## Product Change Notice (PCN)

**PCN Number:** PCN-0454837R-01

SJ2-35863B1-SMT-TR

Reason(s) for Change: *Manufacturing process improvements*

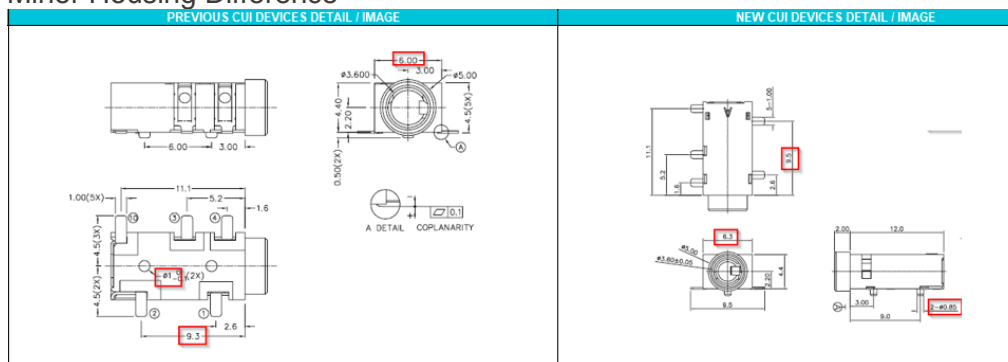
### 1. Minor Housing Difference

## 2. PCB Layout differs

## 3. Housing material differs

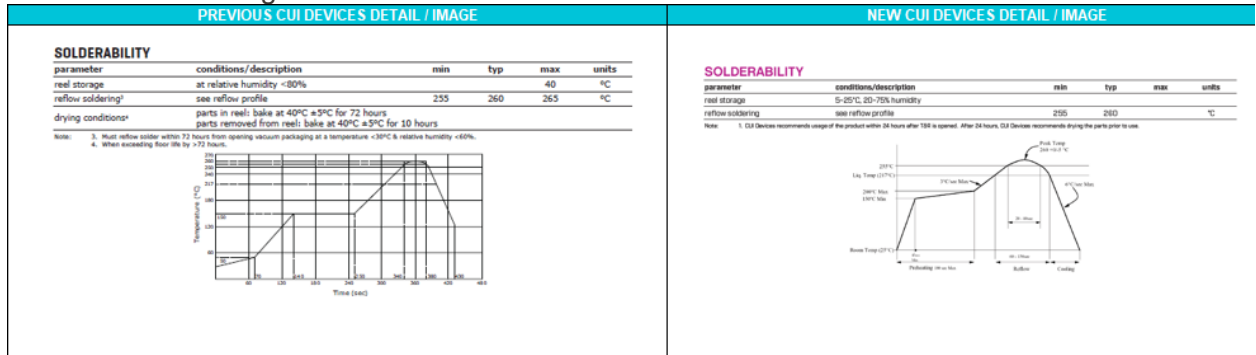
PREVIOUS CUI DEVICES DETAIL / IMAGE	NEW CUI DEVICES DETAIL / IMAGE																																										
<table border="1"> <thead> <tr> <th></th> <th>MATERIAL</th> <th>PLATING</th> </tr> </thead> <tbody> <tr> <td>terminal 1</td> <td>copper alloy</td> <td>silver</td> </tr> <tr> <td>terminal 2</td> <td>copper alloy</td> <td>silver</td> </tr> <tr> <td>terminal 3</td> <td>copper alloy</td> <td>silver</td> </tr> <tr> <td>terminal 4</td> <td>copper alloy</td> <td>silver</td> </tr> <tr> <td>terminal 10</td> <td>copper alloy</td> <td>silver</td> </tr> <tr> <td>plastic</td> <td>PA10T</td> <td></td> </tr> </tbody> </table>		MATERIAL	PLATING	terminal 1	copper alloy	silver	terminal 2	copper alloy	silver	terminal 3	copper alloy	silver	terminal 4	copper alloy	silver	terminal 10	copper alloy	silver	plastic	PA10T		<table border="1"> <thead> <tr> <th>DESCRIPTION</th> <th>MATERIAL</th> <th>PLATING/COLOR</th> </tr> </thead> <tbody> <tr> <td>terminal 1</td> <td>C5210-EH t=0.20</td> <td>gold flash over nickel</td> </tr> <tr> <td>terminal 2</td> <td>C5210-EH t=0.20</td> <td>gold flash over nickel</td> </tr> <tr> <td>terminal 3</td> <td>C5210-EH t=0.20</td> <td>gold flash over nickel</td> </tr> <tr> <td>terminal 4</td> <td>C5210-EH t=0.20</td> <td>gold flash over nickel</td> </tr> <tr> <td>terminal 10</td> <td>C2680-EH t=0.20</td> <td>gold flash over nickel</td> </tr> <tr> <td>housing</td> <td>PA9T (UL94V-0)</td> <td>black</td> </tr> </tbody> </table>	DESCRIPTION	MATERIAL	PLATING/COLOR	terminal 1	C5210-EH t=0.20	gold flash over nickel	terminal 2	C5210-EH t=0.20	gold flash over nickel	terminal 3	C5210-EH t=0.20	gold flash over nickel	terminal 4	C5210-EH t=0.20	gold flash over nickel	terminal 10	C2680-EH t=0.20	gold flash over nickel	housing	PA9T (UL94V-0)	black

MATERIAL	PLATING																																									
terminal 1	copper alloy	silver																																									
terminal 2	copper alloy	silver																																									
terminal 3	copper alloy	silver																																									
terminal 4	copper alloy	silver																																									
terminal 10	copper alloy	silver																																									
plastic	PA10T																																										
DESCRIPTION	MATERIAL	PLATING/COLOR																																									
terminal 1	C5210-EH t=0.20	gold flash over nickel																																									
terminal 2	C5210-EH t=0.20	gold flash over nickel																																									
terminal 3	C5210-EH t=0.20	gold flash over nickel																																									
terminal 4	C5210-EH t=0.20	gold flash over nickel

terminal 10	C2680-EH t=0.20	gold flash over nickel																																									
housing	PA9T (UL94V-0)	black

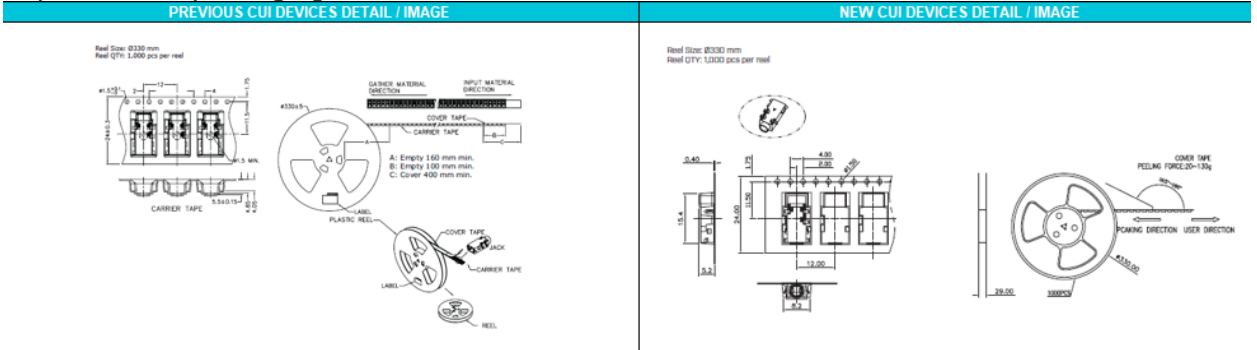
## 4. Reflow Soldering Difference

## 5. Tape and reel packaging differs
